2.4 Core Cooling Systems

The information in this section of the reference ABWR DCD, including all subsections, tables, and figures, is incorporated by reference with the following departures.

Figure 2.4.1a Residual Heat Removal System (RHR-A)

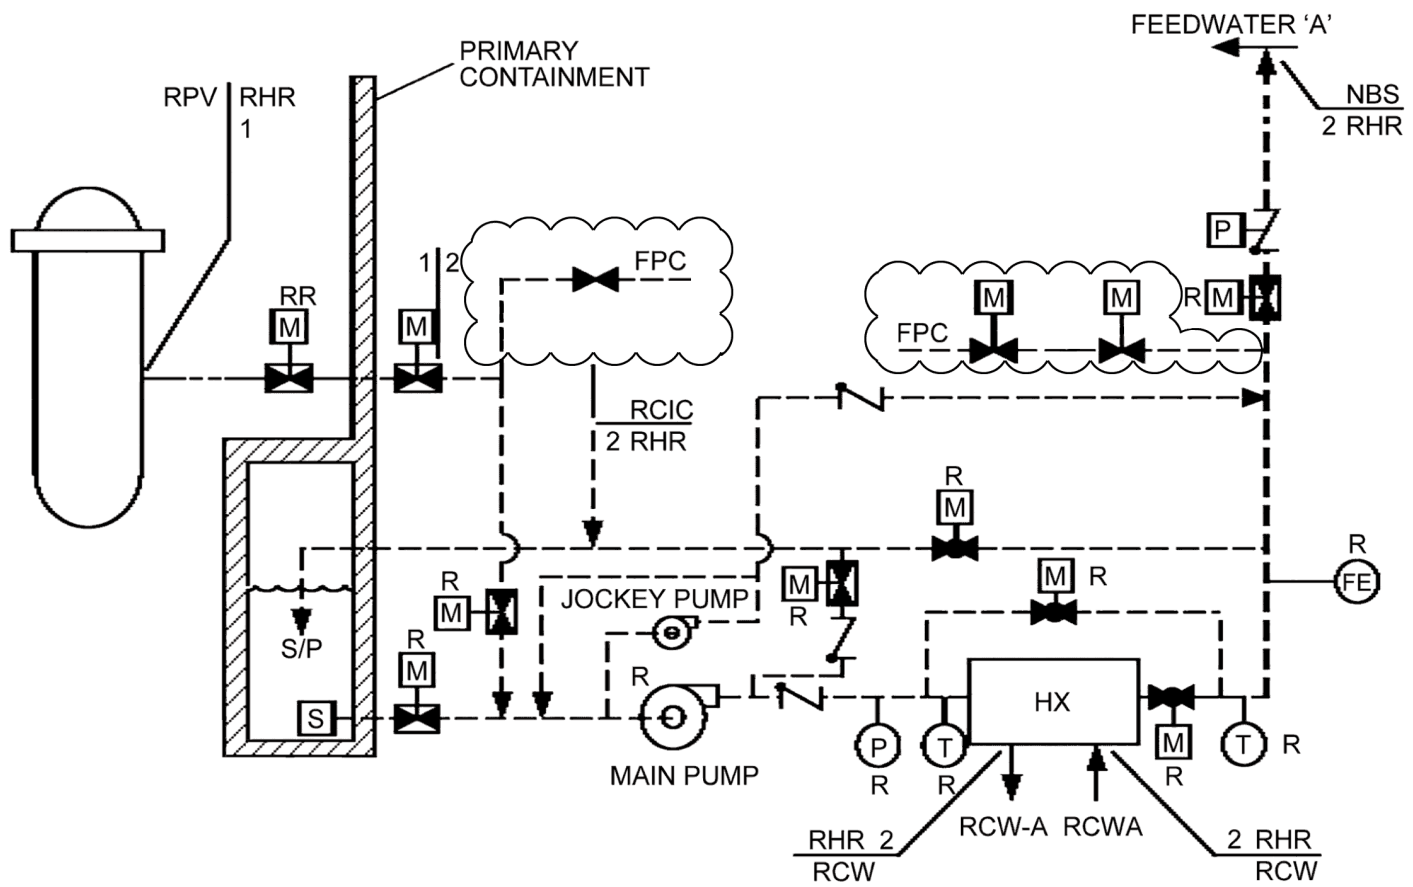
STD DEP T1 2.4-1 (Figure 2.4.1a, Table 2.4.1)

STD DEP T1 2.4-1

The augmented fuel pool cooling mode of the RHR System (Divisions A, B and C) can supplement the Fuel Pool Cooling (FPC) System as follows: (1) directly cooling the fuel pool by circulation fuel pool water through the RHR heat exchanger and returning it to the fuel pool; and (2) while providing shutdown cooling during refueling operations, return the cooled RHR shutdown cooling flow to the fuel pool. Also, this mode provides for fuel pool emergency makeup capability by permitting the RHR pumps (Divisions A, B and C) to transfer suppression pool water to the fuel pool. This mode is accomplished manually by control of individual system components. In the augmented fuel pool cooling mode, the RHR tube side heat exchanger flow rate for Division~~s~~ A, B or C is no less than 350 m^3/h.

The piping and components outside the shutdown cooling suction line containment isolation valves and outside the suppression pool containment isolation valves, and upstream of the suction side of the pump with all its branches have a design pressure of 2.82 MPaG for intersystem LOCA (ISLOCA) conditions. Refer to Figures 2.4.1a, 2.4.1b, and 2.4.1c. ~~For RHR A, the upgraded branch lines from the main pump suction include the path to and including the suppression pool suction valve, the path to the shutdown cooling outboard containment isolation valve, and the path to the jockey pump's discharge check valve including the jockey pump's bypass return line. For RHR B and C, the upgraded branch lines include all the paths listed for RHR A plus the path to (and including the valve) the Fuel Pool Cooling System that branches off~~

~~*the shutdown cooling suction line, titled "From FPC."*~~ For RHR A and B, the upgraded branch lines from the main pump suction include the path to and including the suppression pool suction valve, the path to the shutdown cooling outboard containment isolation valve, the path to the jockey pump's discharge valve including the jockey pump's bypass line and the path to the (and including the valve) the Fuel Pool Cooling System that branches off the shutdown cooling suction, titled, "From FPC." *For RHR-C, the upgraded branch lines include all the paths listed for RHR-A and B plus the pipeline and valves that are part of the AC independent water addition mode that extends from the noncode boundary indicated by "NNS" to the "external connection" outside the "reactor building" and to the Fire Protection System interface indicated by "FP."*

Figure 2.4.1b Residual Heat Removal System (RHR-B)

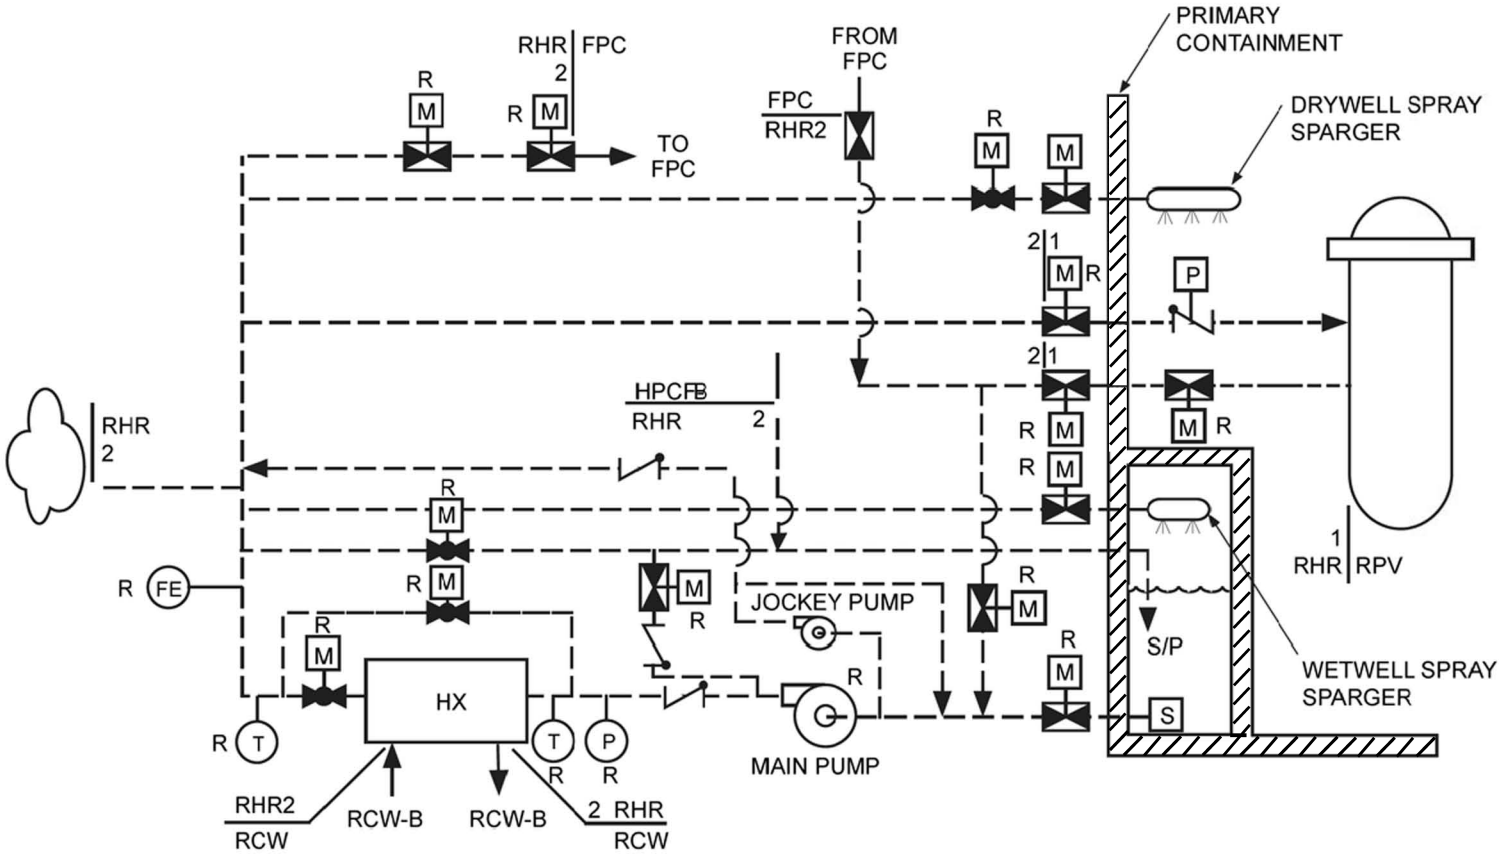
STD DEP T1 2.14-1 (Figure 2.4.1b, Figure 2.4.1c, Figure 2.4.3)

Figure 2.4.2 Leak Detection and Isolation System Interface Diagram

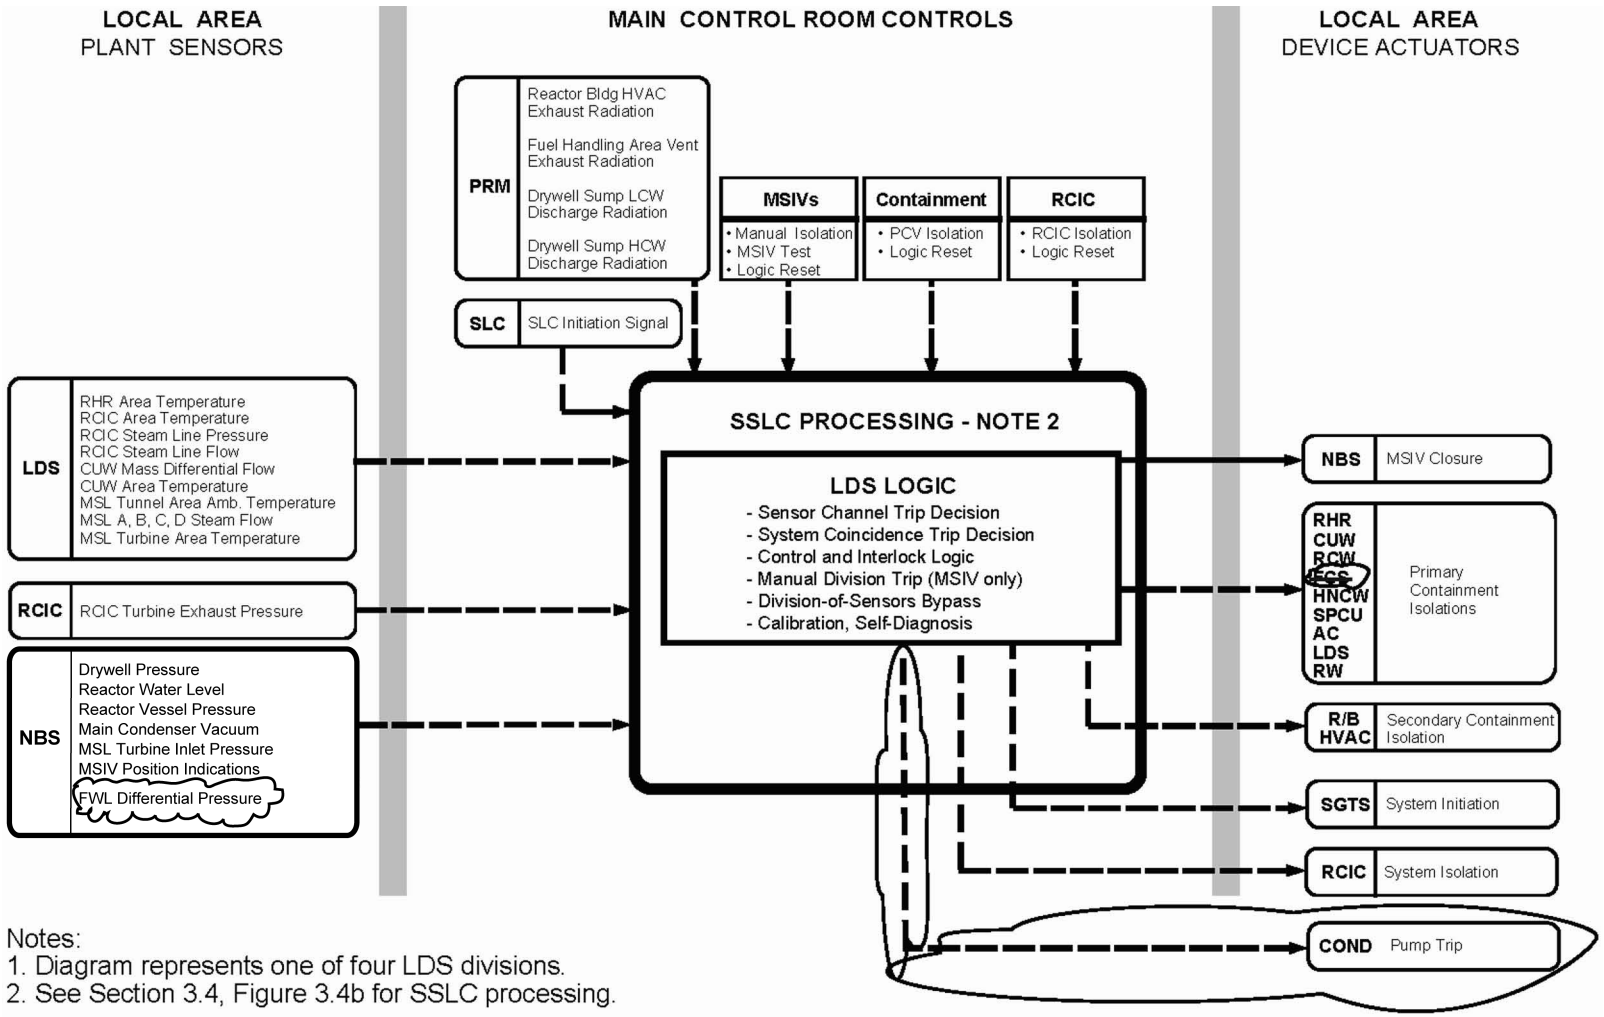
STD DEP T1 2.4-2 (Leak Detection System) Figure 2.4.3

STD DEP T1 2.14-1 (FCS, Figure 2.4.3)

~~(10) Isolation of the Flammability Control System (FCS) on a signal indicating high drywell pressure or low reactor water level.~~

(10) ~~(11)~~ Isolation of the drywell sump low conductivity waste (LCW) and high conductivity waste (HCW) discharge lines on a signal indicating high drywell pressure or low reactor water level. Also, each discharge line is individually isolated on a signal indicating high radioactivity in the discharged liquid waste; only one channel is used for this function.

(11) ~~(12)~~ Isolation of the LDS fission products monitor drywell sample and return lines on a signal indicating high drywell pressure or low reactor water level.

(12) ~~(13)~~ The LDS provides to the neutron monitoring system a signal indicating a high drywell pressure or low reactor water level.

(13) The LDS provides a trip of the condensate pumps on signals that indicate high drywell pressure and high differential pressure between the feedwater lines.

Figure 2.4.4a Reactor Core Isolation Cooling System

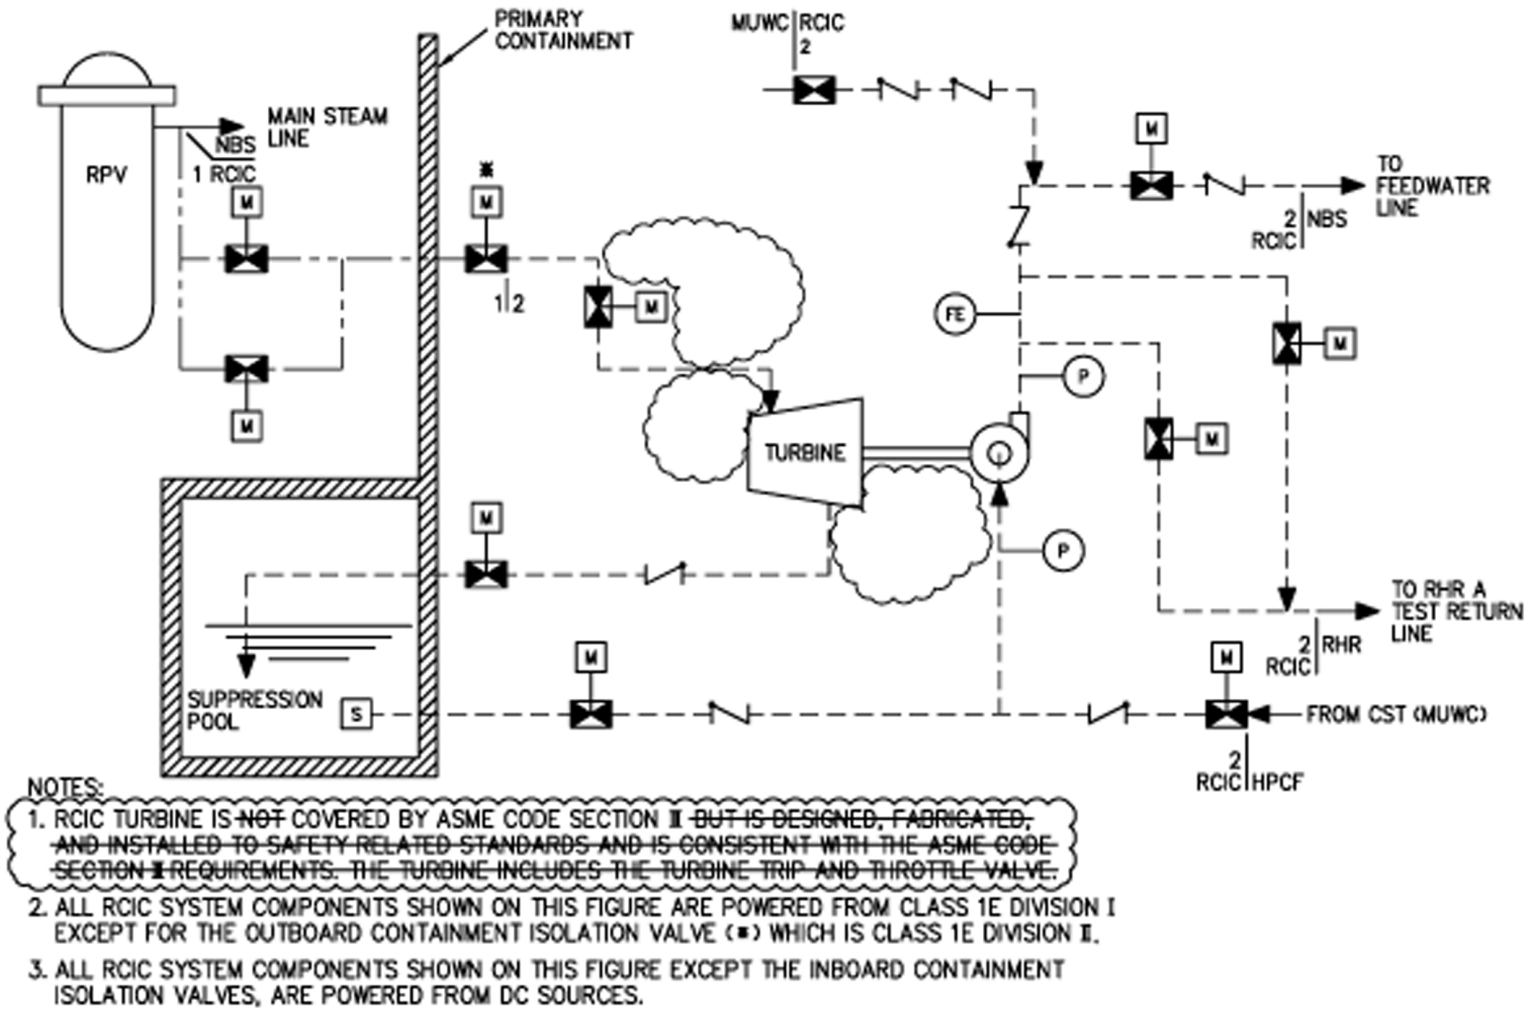
STD DEP T1 2.4-3 (Figure 2.4.4a, Table 2.4.4.)

STD DEP T1 2.4-3

The RCIC turbine is tripped if a low pump suction pressure condition is present.

(1) Piping and component from the pump suction MOV's up to the pump inlet,

~~(2) Barometric condenser and associated equipment.~~

have a design pressure of 2.82 MPaG for intersystem loss-of-coolant accident (ISLOCA) conditions.

1. RCIC TURBINE IS ~~NOT~~ COVERED BY ASME CODE SECTION Ⅱ ~~BUT IS DESIGNED, FABRICATED, AND INSTALLED TO SAFETY RELATED STANDARDS AND IS CONSISTENT WITH THE ASME CODE SECTION Ⅲ REQUIREMENTS. THE TURBINE INCLUDES THE TURBINE TRIP AND THROTTLE VALVE.~~
2. ALL RCIC SYSTEM COMPONENTS SHOWN ON THIS FIGURE ARE POWERED FROM CLASS 1E DIVISION I EXCEPT FOR THE OUTBOARD CONTAINMENT ISOLATION VALVE (*) WHICH IS CLASS 1E DIVISION Ⅱ.
3. ALL RCIC SYSTEM COMPONENTS SHOWN ON THIS FIGURE EXCEPT THE INBOARD CONTAINMENT ISOLATION VALVES, ARE POWERED FROM DC SOURCES.
